State of Wisconsin \ Department of Commerce

RULES IN FINAL DRAFT FORM

Rule No.: **Chapters Comm 20-25**

Relating to: **Uniform (1-2 Family) Dwelling Code**

FIGURE 21.25-A
BRACED WALL PANELS AND BRACED WALL LINES

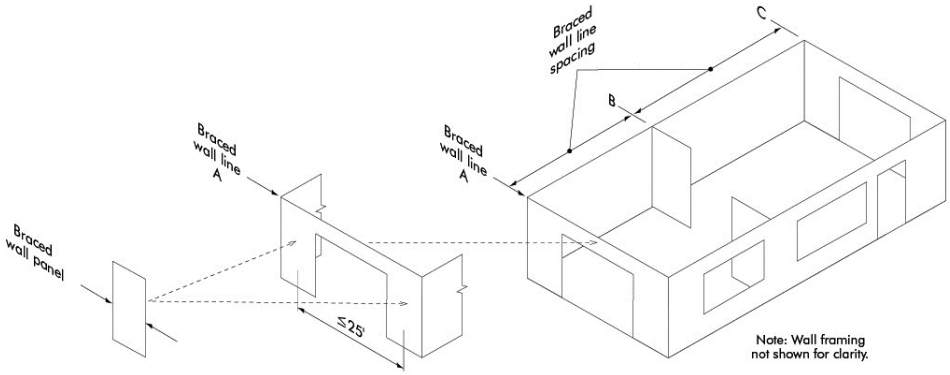
3. ‘Offsets.’ Offsets in braced wall lines, out-of-plane of up to 4 feet shall be permitted provided that the total out-to-out offset dimension in any braced wall line is not more than 8 feet per Figure 21.25-C.

Wall Supporting:	**AMOUNT OF BRACING PER WALL LINE[4]** Braced segments shall be located at least every 25-ft o.c. but not less than the following percentages:	
	Wood Structural Panel Sheathing [Sub. (8) (b) 4., (9) (b) &(9) (c)]	**Other Methods Permitted [Sub. (8) (b) 1, 2, 3, 5& 6.]**
Roof only[1]	16%	16%[2]
Floor and roof	16%	25%[2]
Two Floors and roof	25%	35%[3]

FIGURE 21.25-D
ANGLED CORNERS

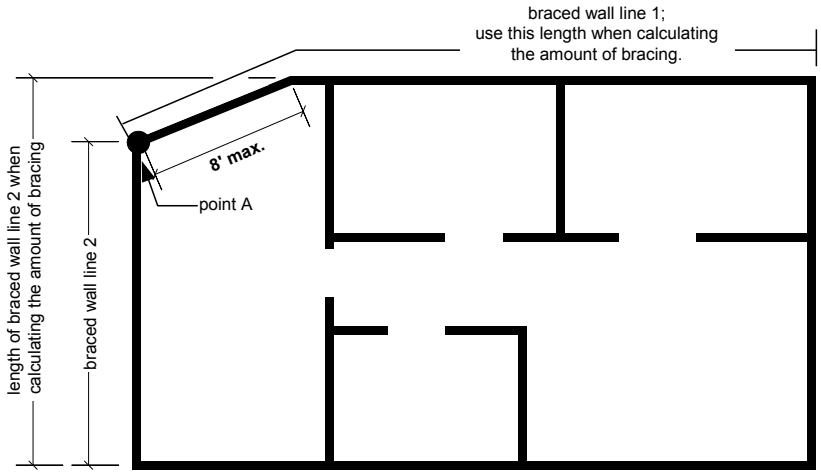
(f) *Angled Corners.* 1. At corners, braced wall lines may angle out of plane up to 45 degrees with a maximum diagonal length of 8 feet.

2. When determining the percentage of bracing, the length of each braced wall line shall be determined as shown in Figure 21.25-D.

Note: This is at Point A as shown in Figure 21.25-D.

4. Where an angled corner is constructed at an angle equal to 45 degrees and the diagonal length is no more than 8 feet in length, the angled wall may be considered as part of either of the adjoining braced wall lines, but not both.

5. Where the diagonal length is greater than 8 feet, it shall be considered its own braced wall line and be braced in accordance with par. (b).

FIGURE 21.25-E
ALTERNATE BRACING METHOD
WITH EXTENDED HEADER AND TIE DOWNS

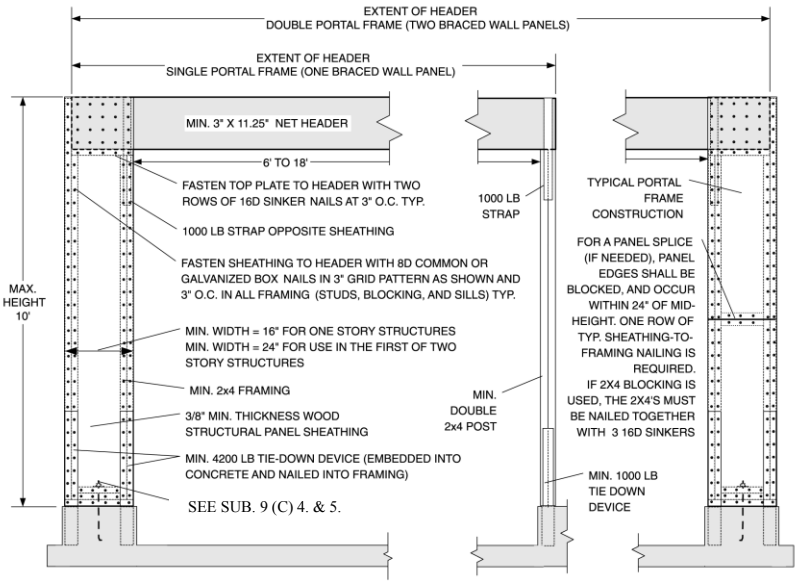
b. Each panel shall be sheathed on one face with a single layer of 3/8-inch-minimum-thickness wood structural panel sheathing nailed with 8d common or galvanized box nails in accordance with Figure 21.25-E.

c. The wood structural panel sheathing shall extend up over the header and shall be nailed in accordance with Figure 21.25-E.

5. ‘Alternate bracing method with Extended Header Over Opening and Tie Downs, in a wall supporting a floor and roof only.’ Each wall panel shall be braced in accordance with subd. 4., except that each panel shall have a length of at least 24 inches.

FIGURE 21.25-F
CONTINUOUSLY-SHEATHED BRACED WALL LINE

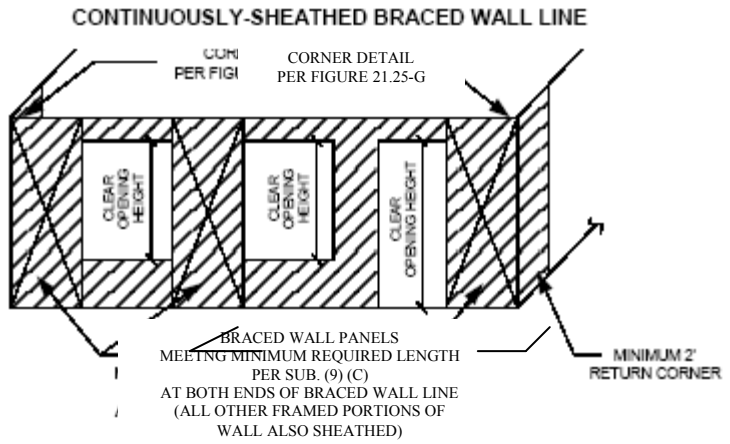
2. ‘Continuously-sheathed braced wall line requirements.’ Continuously-sheathed braced wall lines shall be constructed in accordance with Figure 21.25-F and shall comply with all of the following requirements:

FIGURE 21.25-G
TYPICAL EXTERIOR CORNER FRAMING FOR CONTINUOUS STRUCTURAL PANEL SHEATHING SHOWING REQUIRED STUD-TO-STUD NAILING

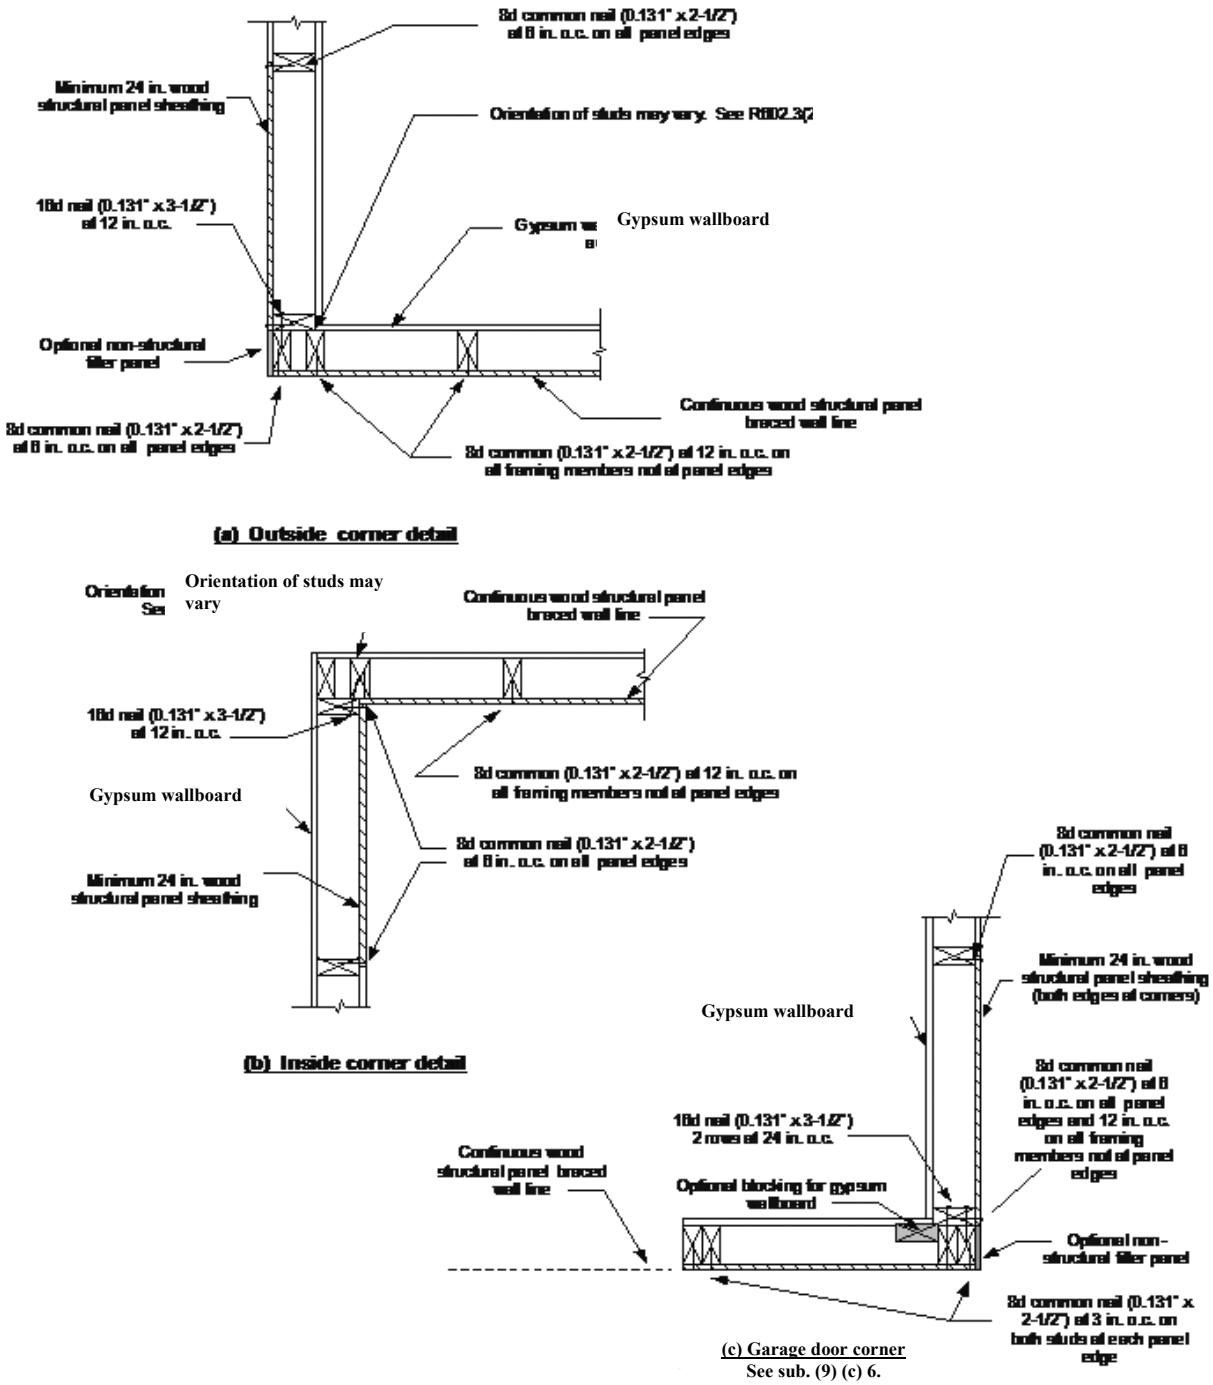
c. Exterior corner framing shall be constructed and fastened in accordance with details in Figure 21.25-G.

d. Corners at the ends of walls using this option shall be constructed in accordance with Figure 21.25- G. Where 6:1 ratio segments are used at the ends of braced wall lines, a 2 foot minimum width wood structural panel must be installed on the corner return as shown in Figure 21.25-F. An 800 lb tie down may be installed in lieu of a 2 foot corner return, as shown in Figure 21.25-H.

Figure 21.25-H
CONTINUOUSLY-SHEATHED BRACED WALL LINE WITHOUT CORNER RETURN

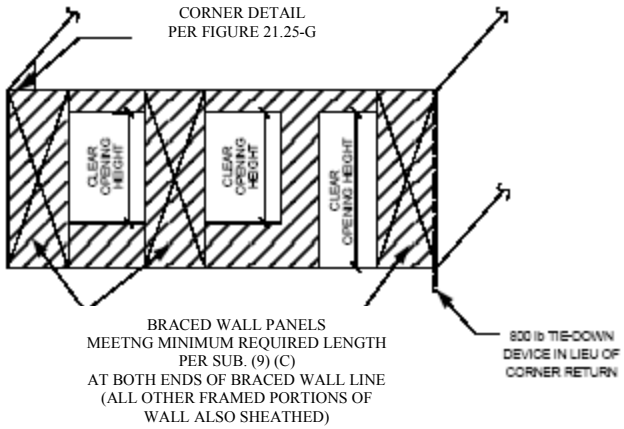
d. Figures 21.25-H, 21.25-I and 21.25-J provide alternative construction options to Figure 21.25-F, when 2 foot wide wood structural panels are not available at the corners of continuous sheathed wall lines and the return wall lines.

FIGURE 21.25-K

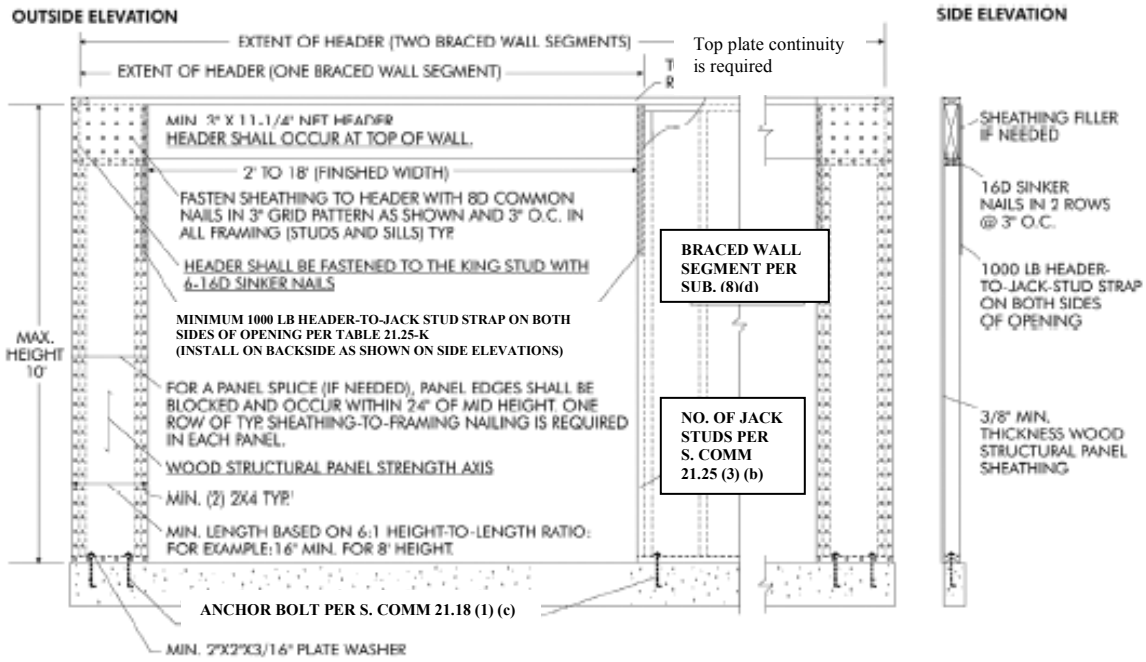
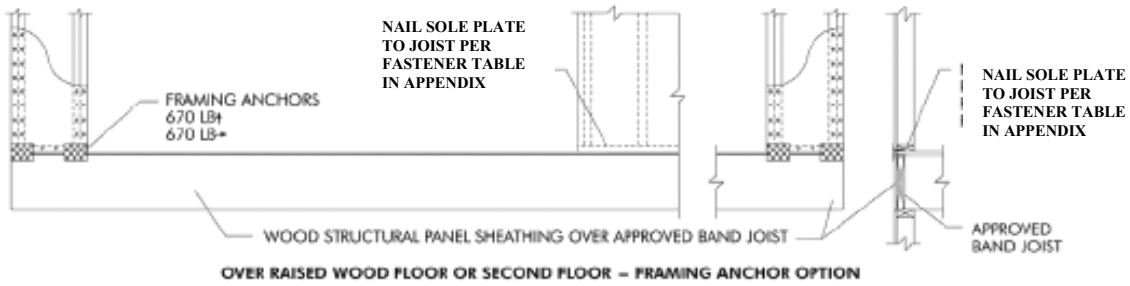
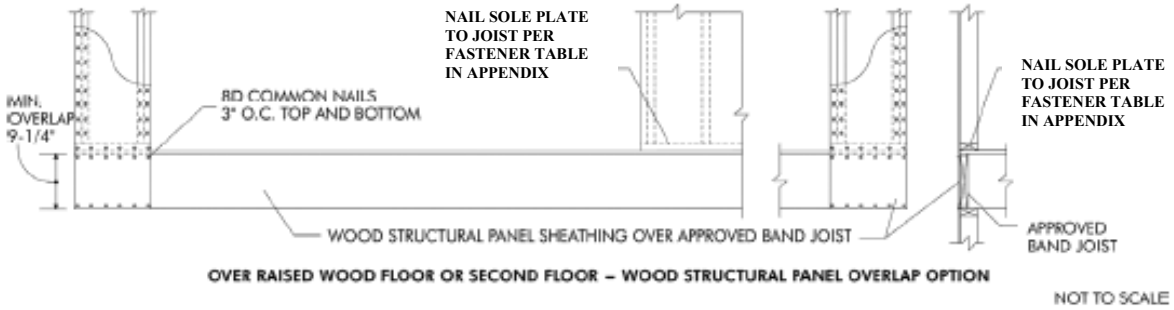
5. '6:1 aspect ratio continuous structural panel sheathing with extended header.' a. Wall segments having a maximum 6:1 height to width ratio are permitted only when built in accordance with Figure 21.25-K.

g. For purposes of resisting wind pressures acting perpendicular to the wall, the minimum requirements of Figure 21.25-K are sufficient for wind speeds less than 110 mph in exposure category B.

I. 6:1 aspect ratio segments with extended header are permitted over raised wood floors or second story applications, when constructed in accordance with rim board/band joist connection in Figure 21.25-K (b) or (c).

Detail A

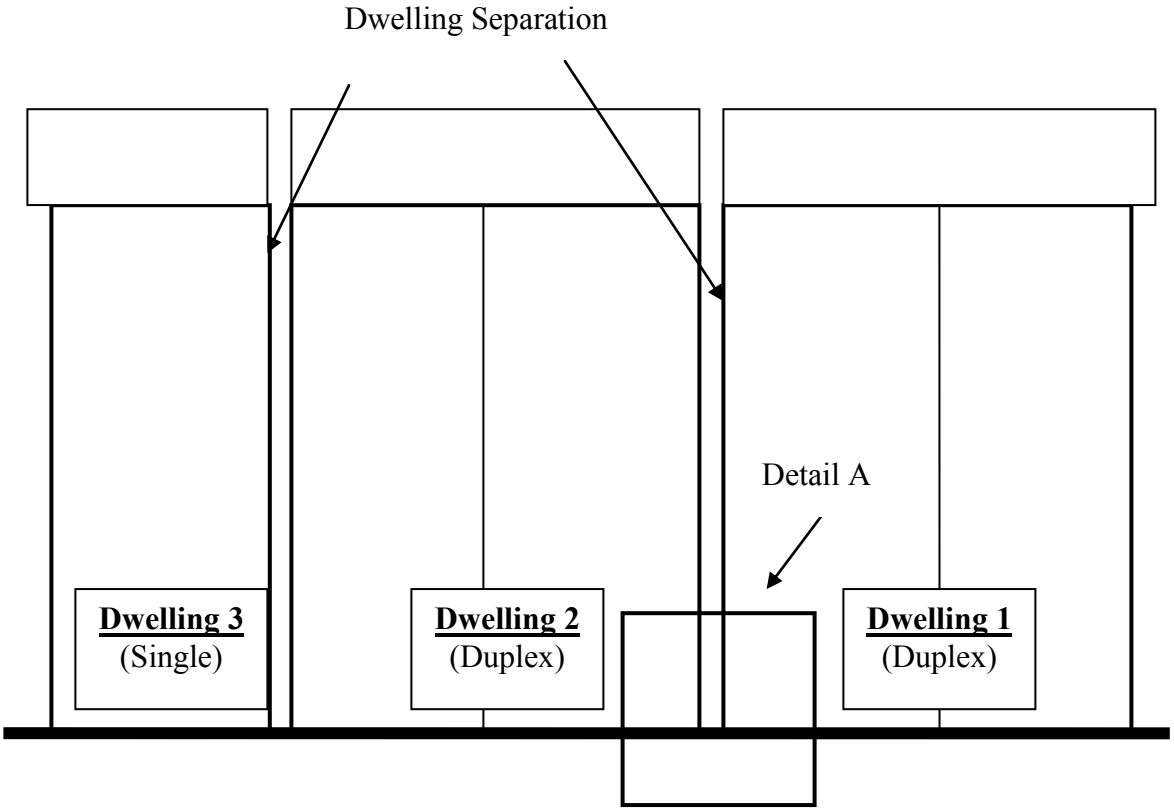
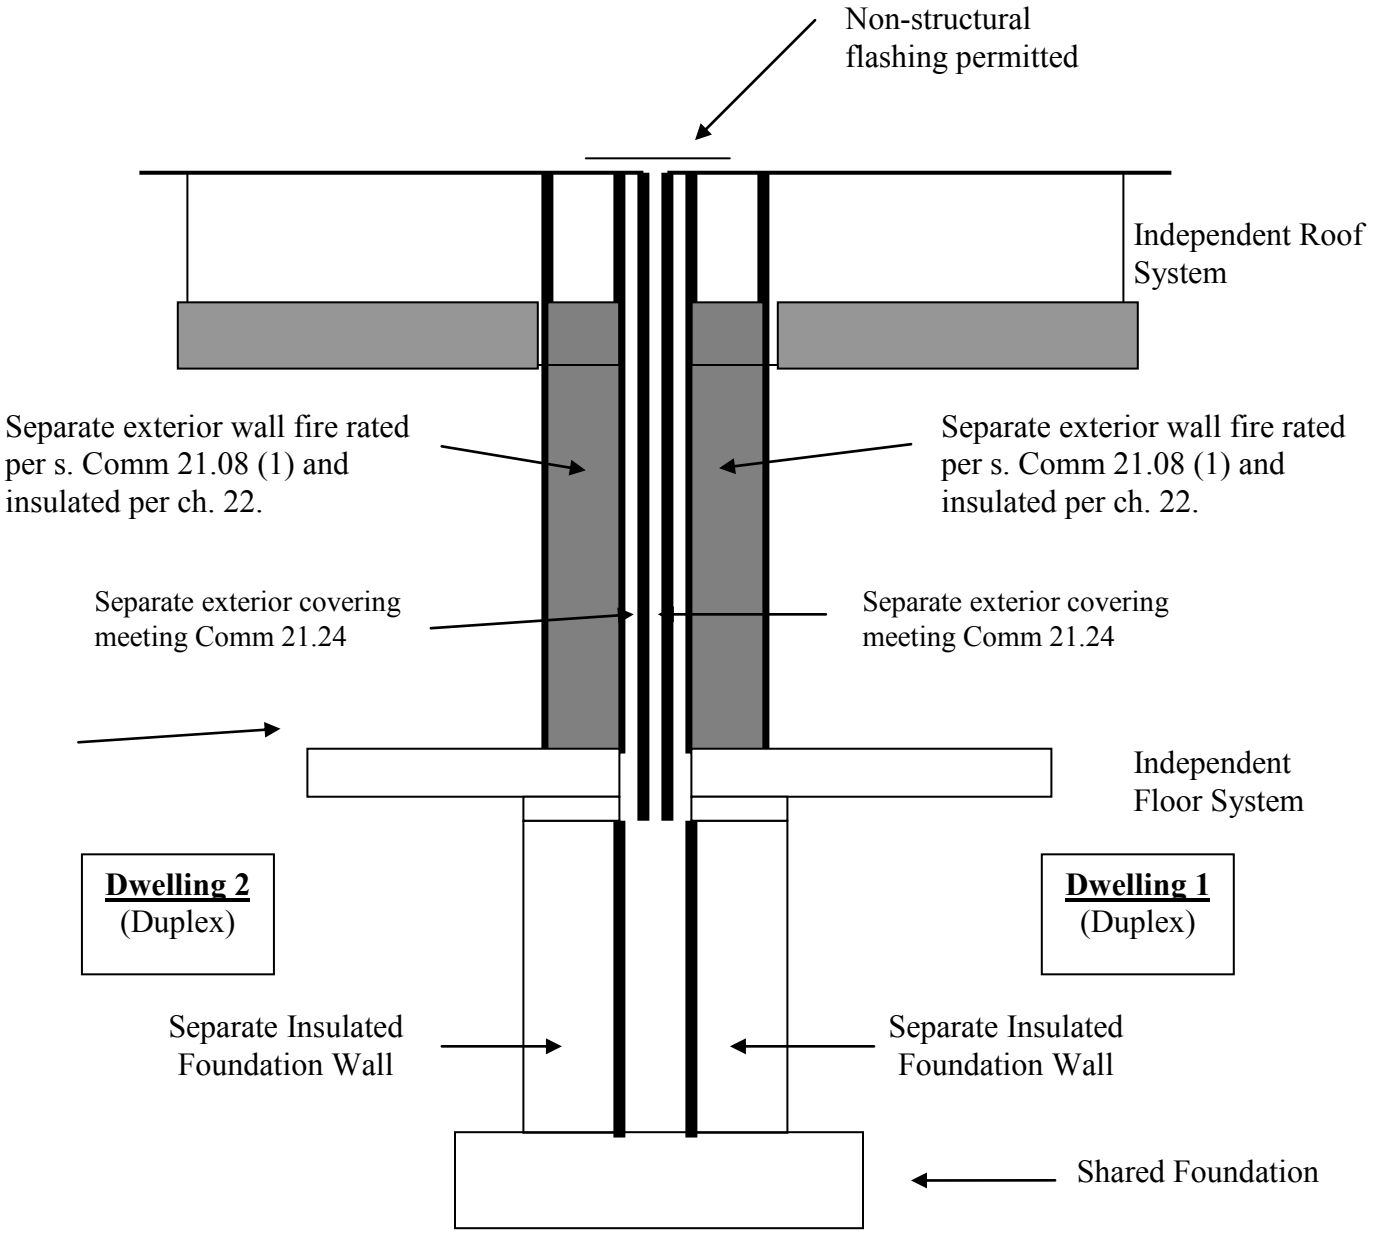
APPENDIX section 20.04(6) added:
[Note to Revisor: This material should be the very first page of the appendix.]

Normally, for 3 or more attached dwelling units, the Commercial Building Code (CBC) applies. Attached means some construction (other than footings and their bearing material) is shared by the units.

Where 3 or more adjacent but unattached dwelling units are each built with the outside walls that comply with the Uniform Dwelling Code (UDC), the UDC applies throughout and the CBC does *not* apply, even if those outside walls are adjacent to or adjoin each other. If flashing is added over the top of two such adjoining walls, the UDC would still apply.
